工程指示 / 要求簡箋(E.I.)

工程指示編號：EI / 0748 / 19 修改版次：
工程編號：J-836 工程名稱：日出康城 7 期 平台
工程項目：WINDOW WALL (WW1) 鐵件生產 ROOF
收件人：Maggie 發件人：大明 日期：25/06/2019

250x150x16mm 扁通切割成 60x150x60x16mm 鐵槽

[1B2a-1]

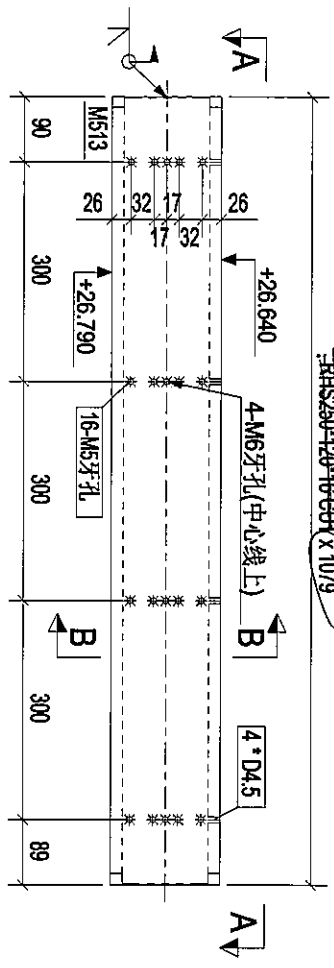
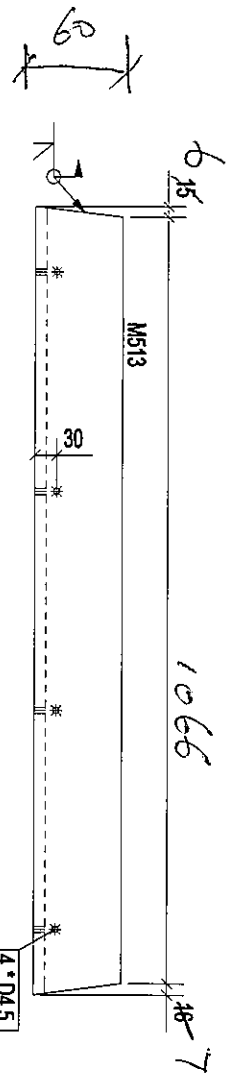
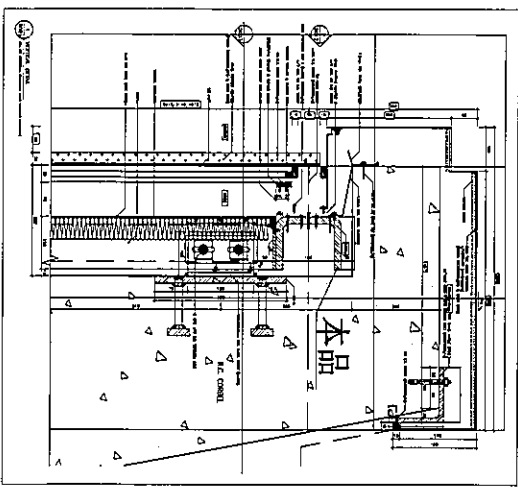
修改说明: 增加Φ4.5孔。

[1B2a-2]

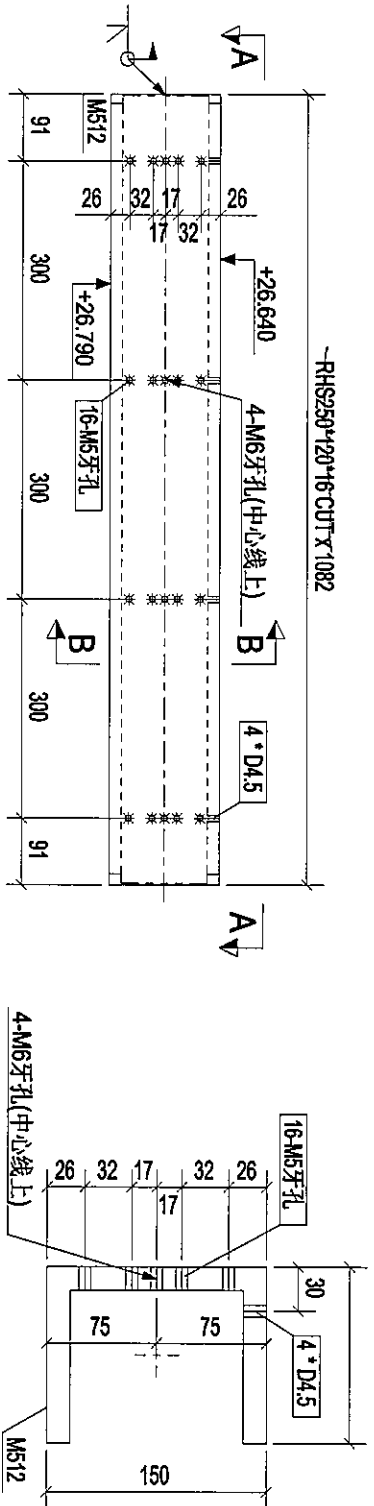
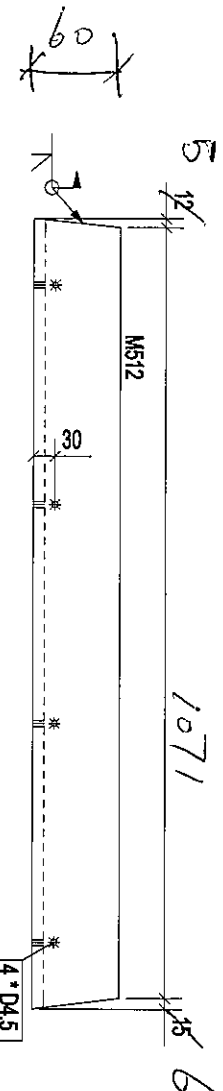
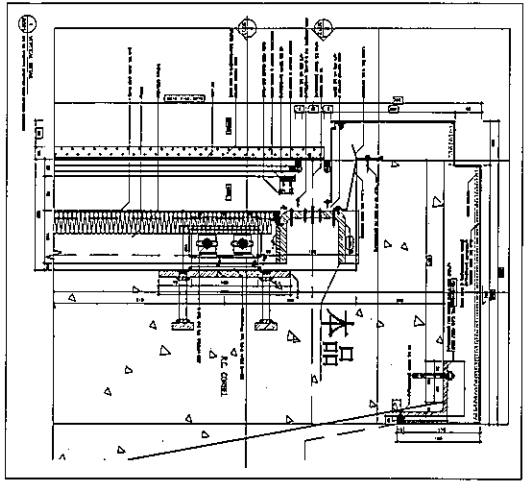
修改说明: 增加Φ4.5孔。

[1B2a-4]

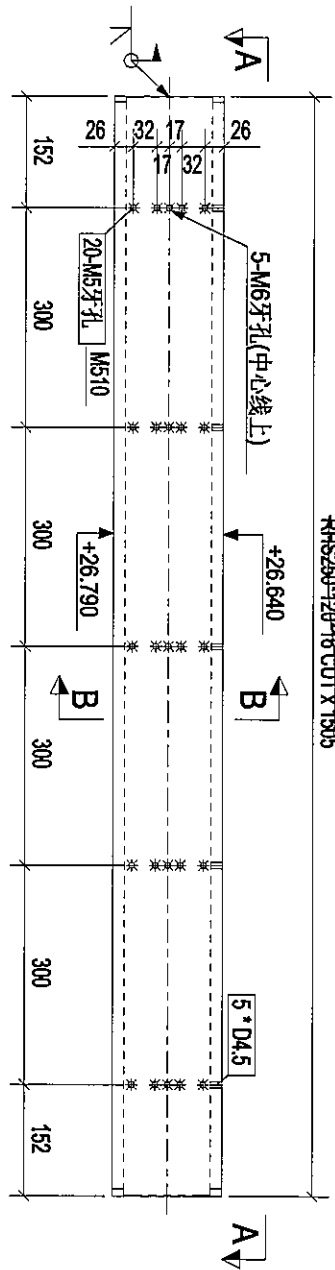
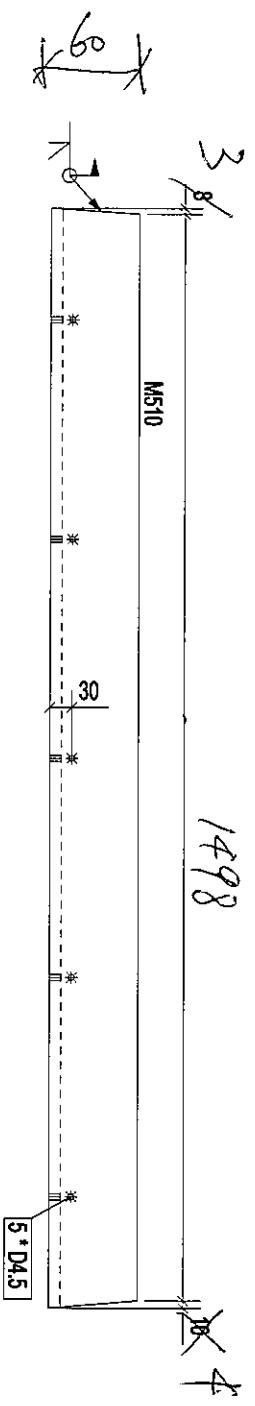
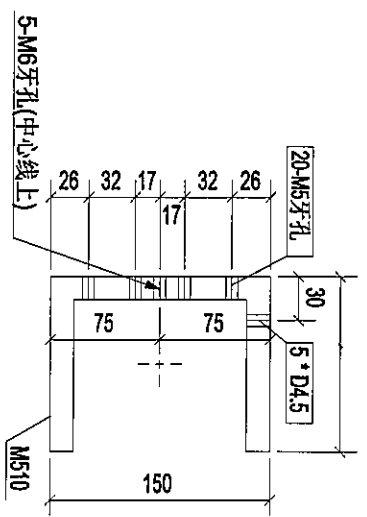
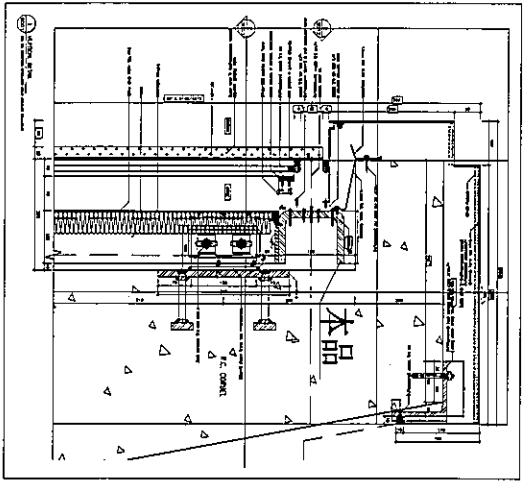
修改说明: 增加Φ4.5孔。

[1B2a-5]

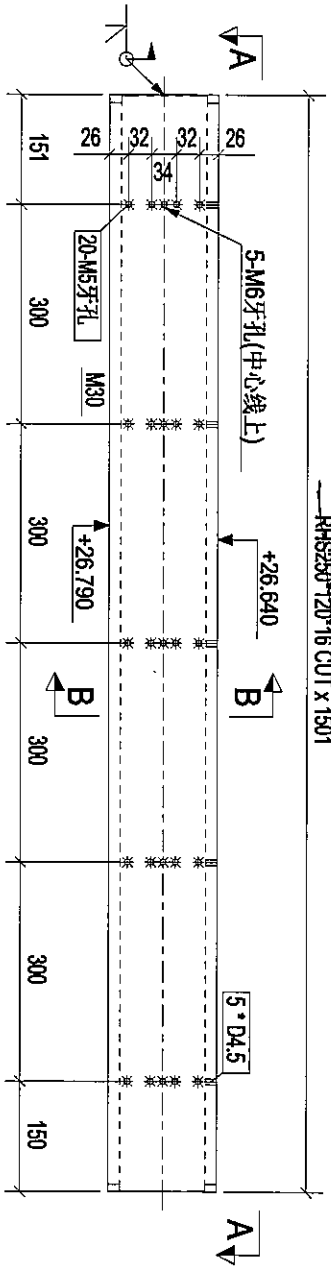
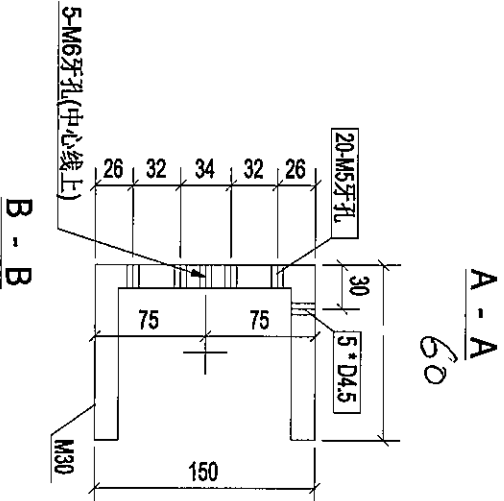
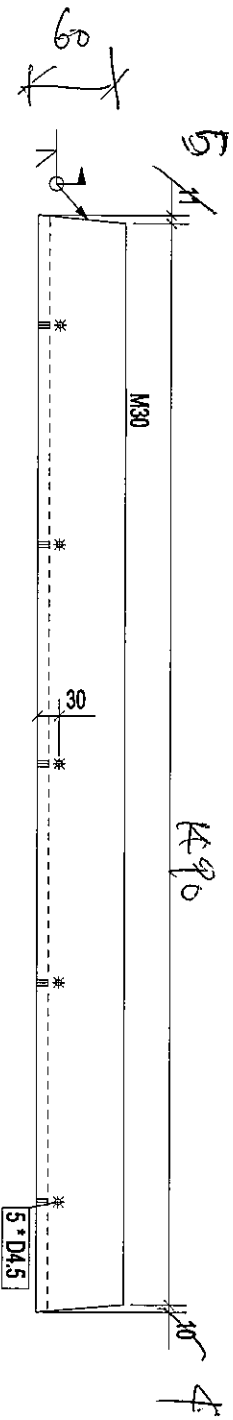
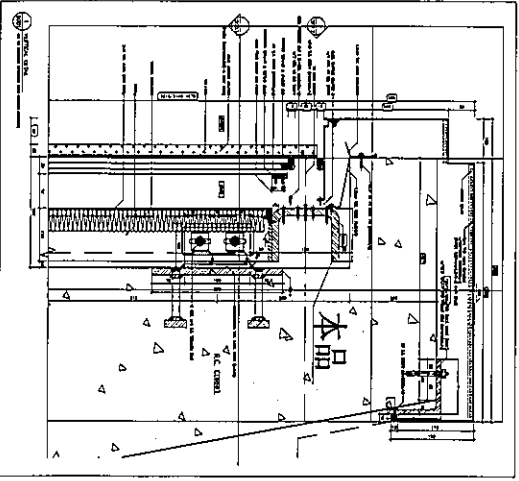
修改说明: 增加Φ4.5孔

[1B2a-6]

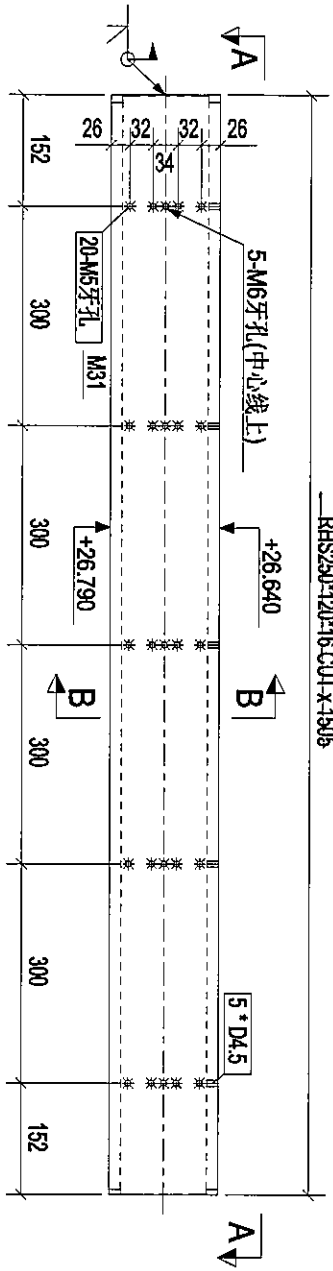
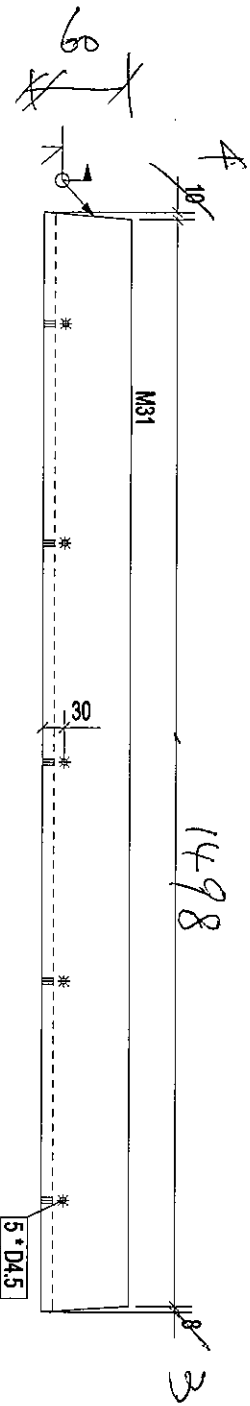
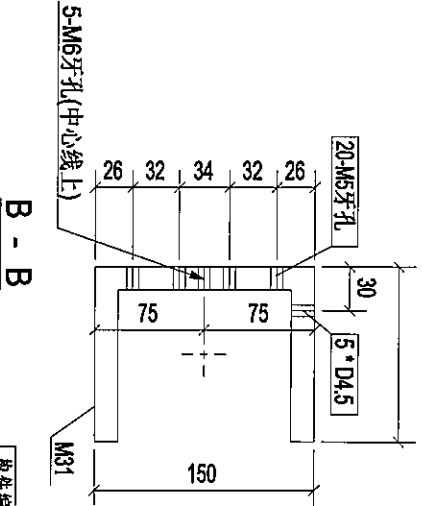
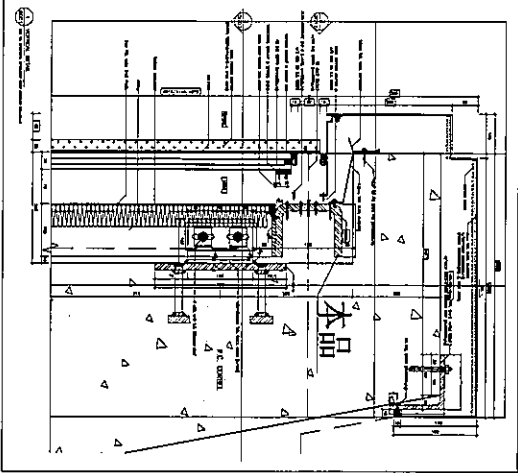
修改说明: 增加Φ4.5孔。

| [1B2a-7] | | | | |

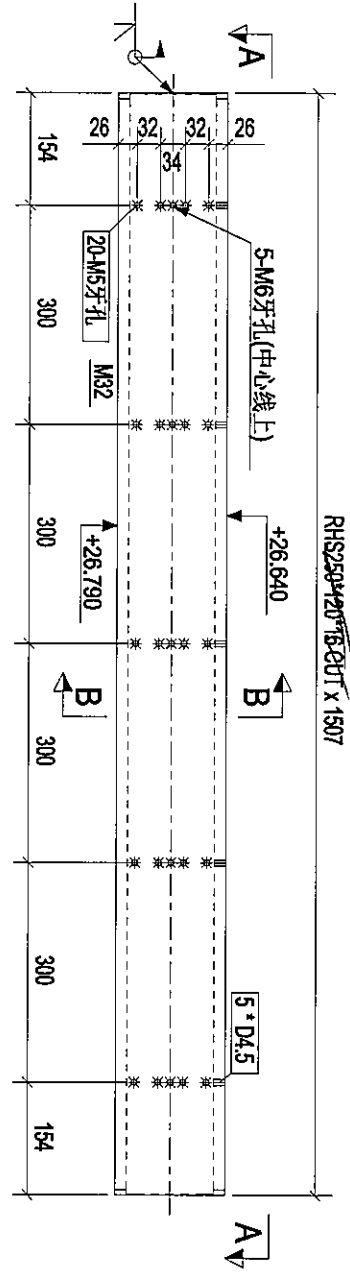
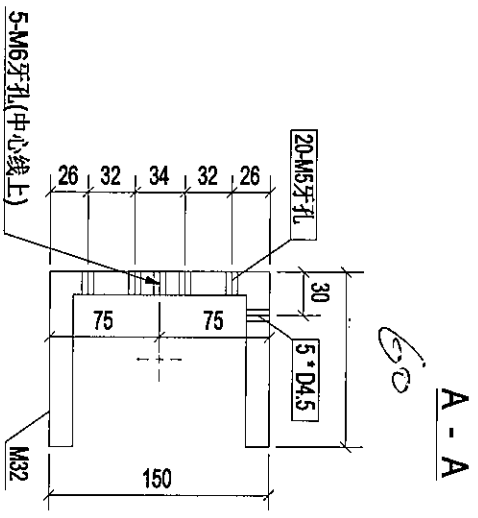
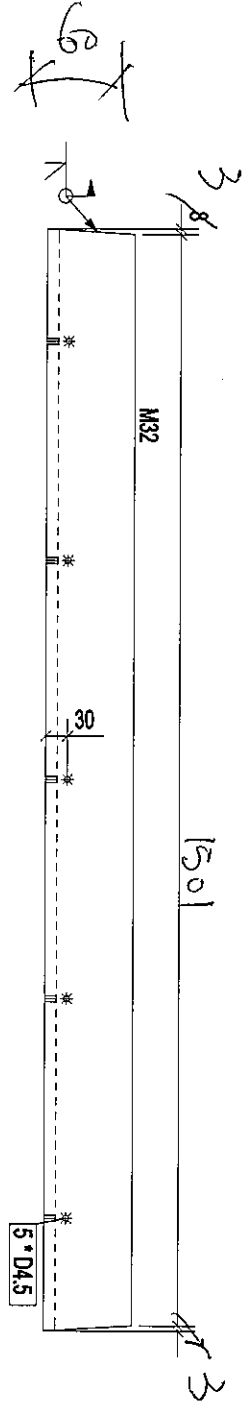
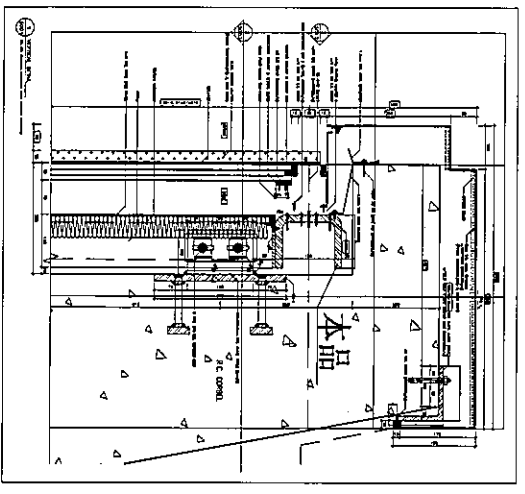
修改说明: 增加Φ4.5孔。

构件: 1B2a-8

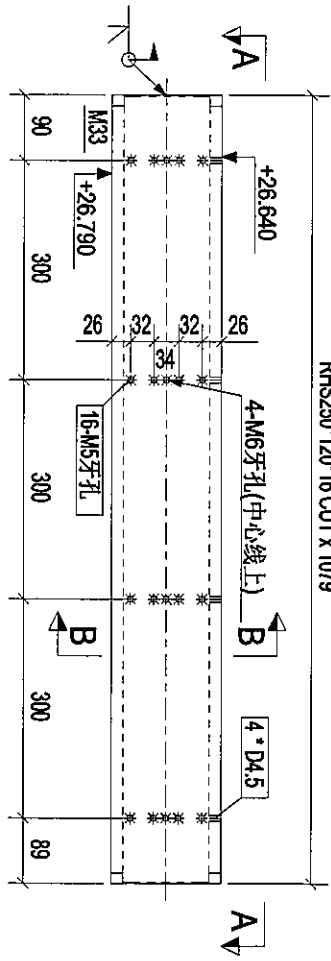
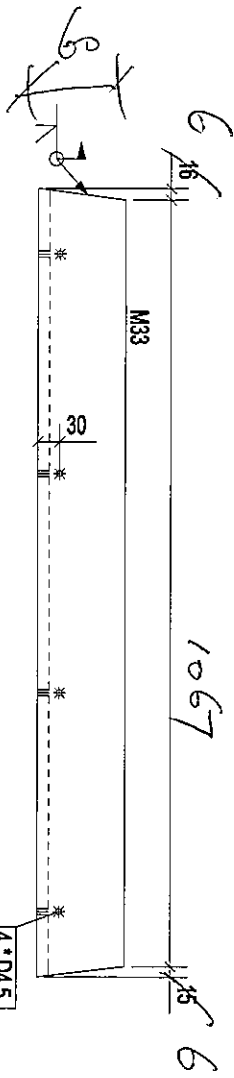
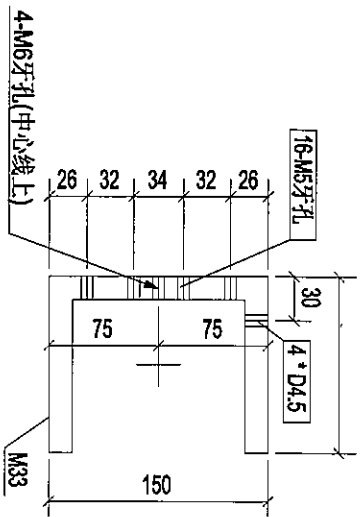
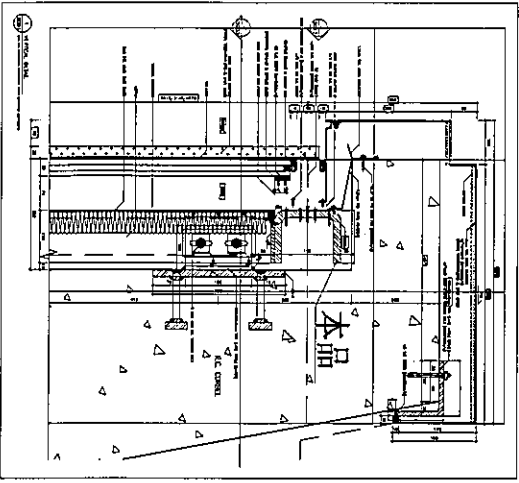
修改说明: 增加 $\Phi 4.5$ 孔。

| [1B2a-9] | | | |

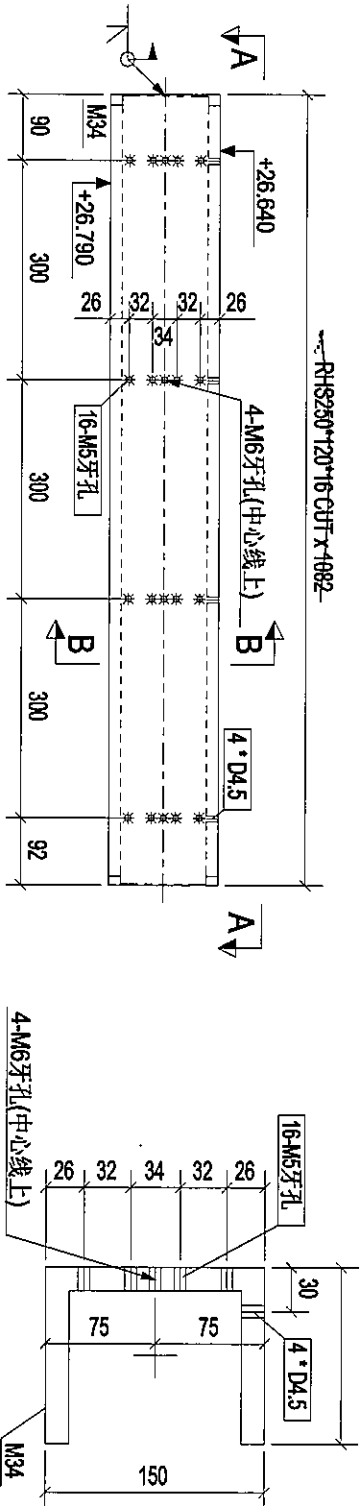
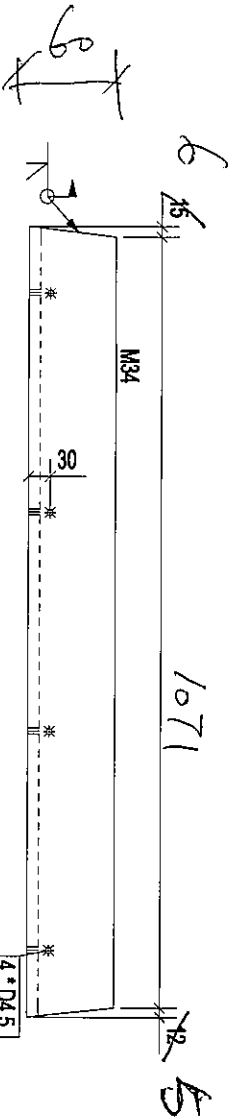
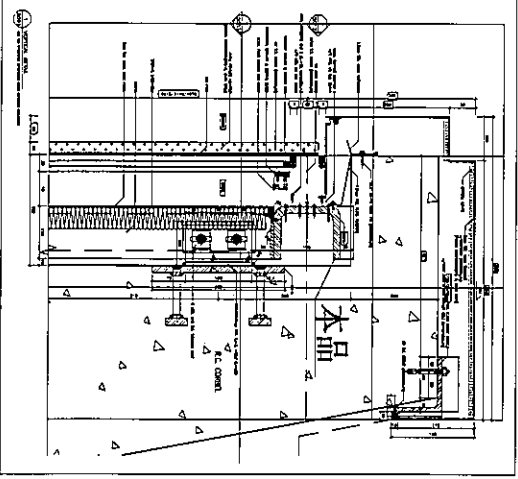
修改说明: 增加Φ4.5孔。

构件: 1B2a-10

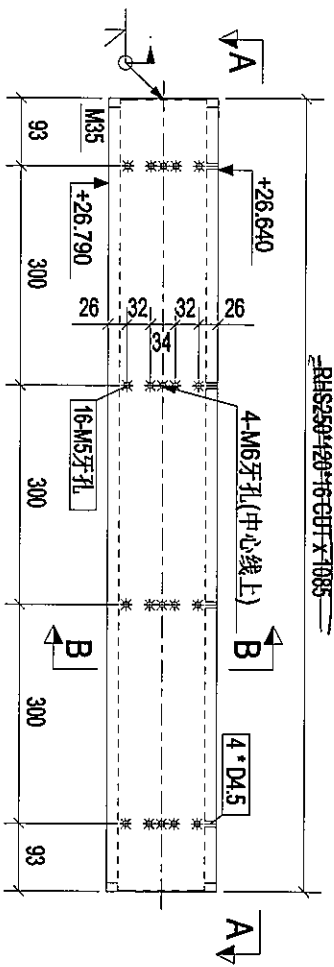
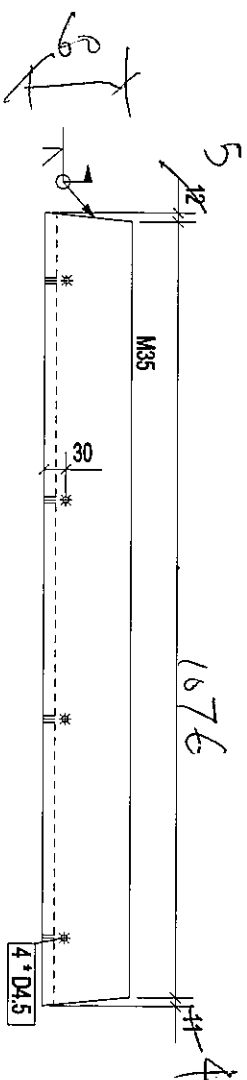
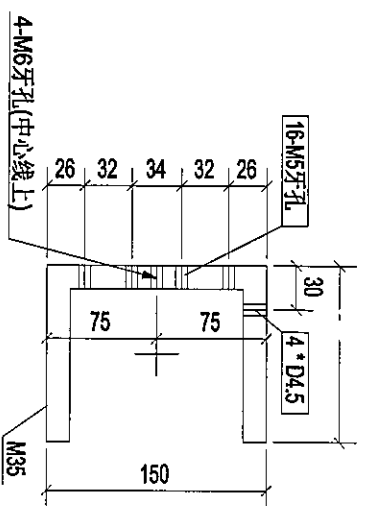
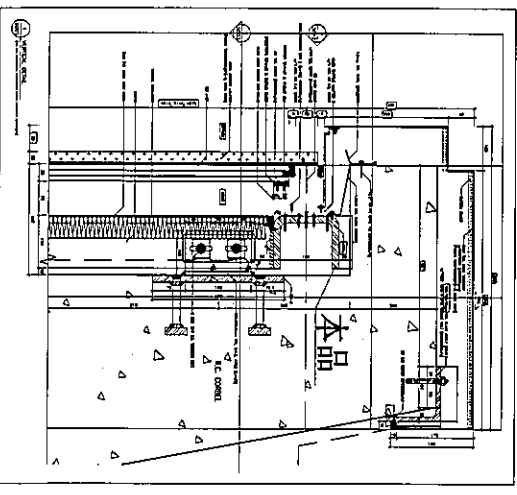
修改说明: 增加Φ4.5孔。

| [1B2a-11] | | |

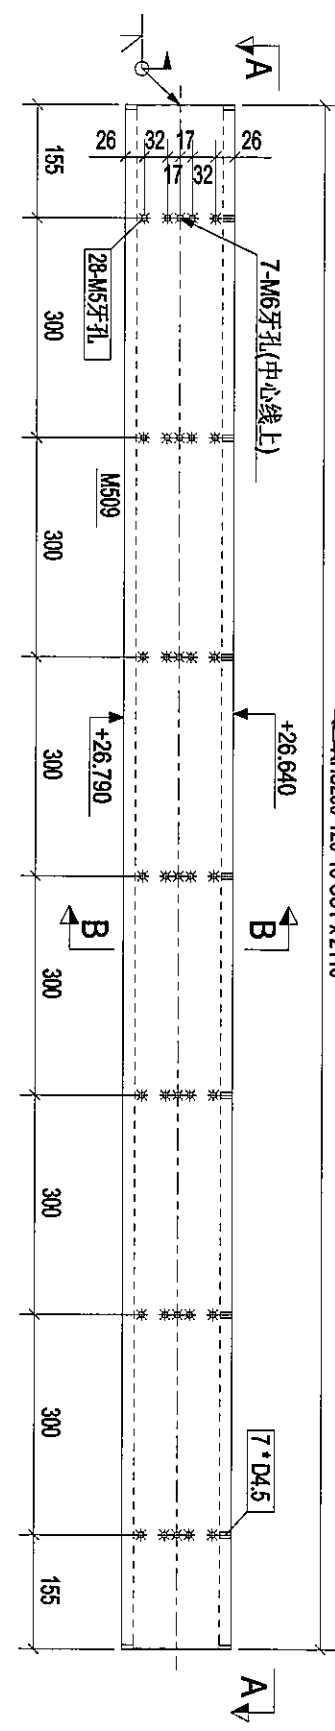
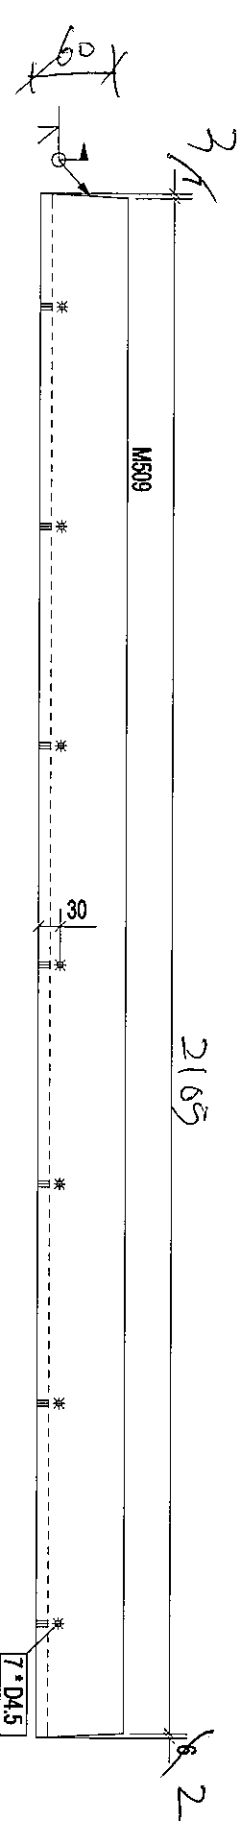
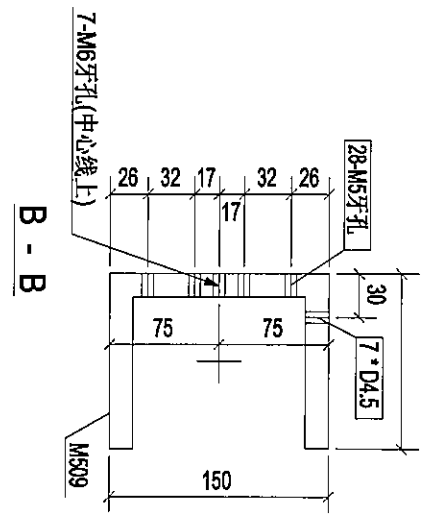
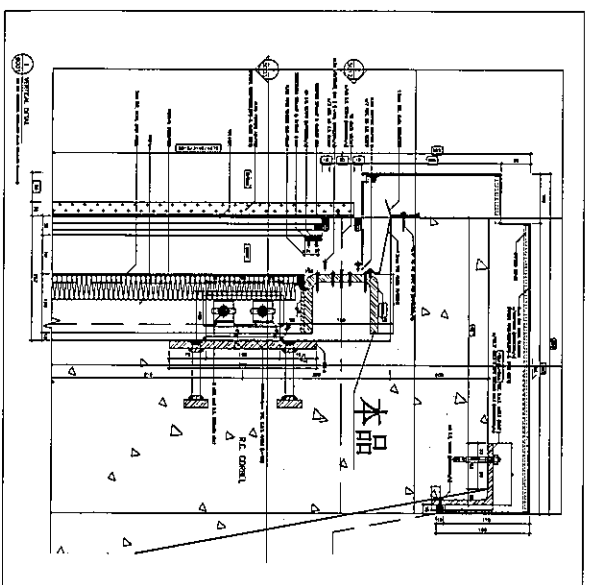
60x150x60x16mm CLANKER CL=2110
 说明: 因增加Φ4.5孔而变出来的新编号。 (11)
